MUNICIPALITY OF ANCHORAGE

MEMORANDUM

SUBJECT: **Case 2016-0044, Major Site Plan Review for Muldoon Town Square Park – Phase I**

PROJECT MANAGEMENT & ENGINEERING DEPARTMENT	MULDOON TOWN SQUARE PARK TRACT A PROJECT No. XX-XX	DATE 3/02/2016 ACCT. NO.	SHEET
PLANTING PLAN		1"=20'	L3
		SCALE: NTS

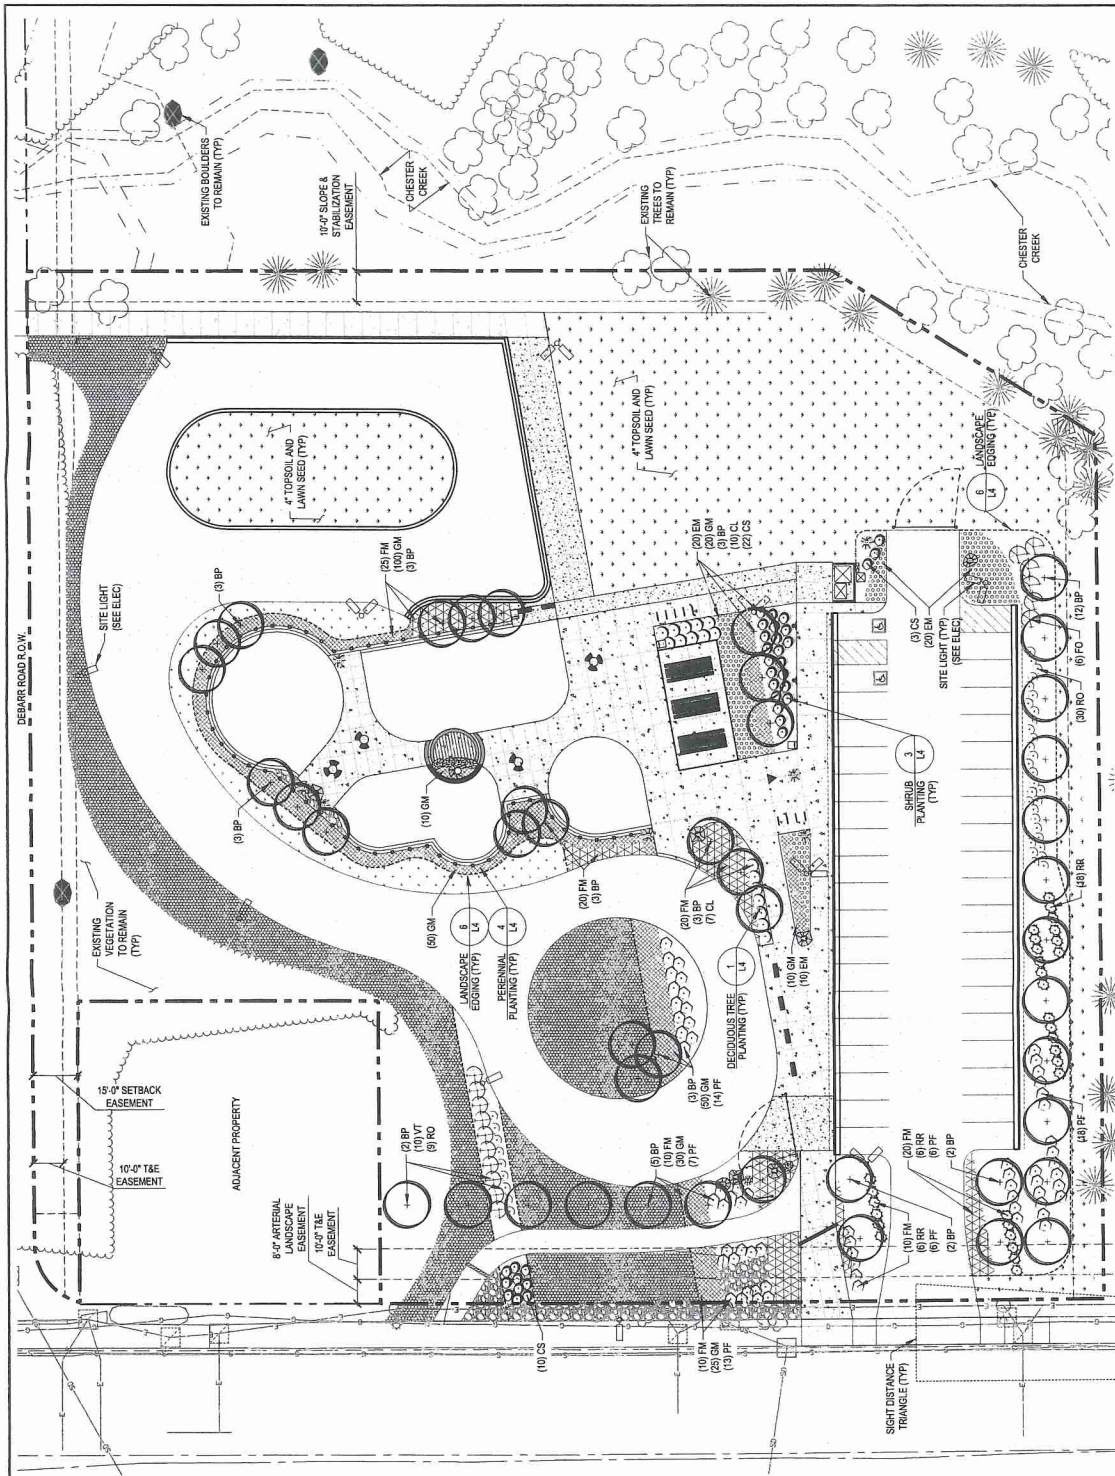
There is a discrepancy between plans: sheets 3 and 4 show a “raingarden” in the northwest corner of the site (adjacent to Tract B1A) yet, sheet L3 shows “existing vegetation to remain”. Staff spoke to the project landscape architect and confirmed that sheet L3 is the correct concept.
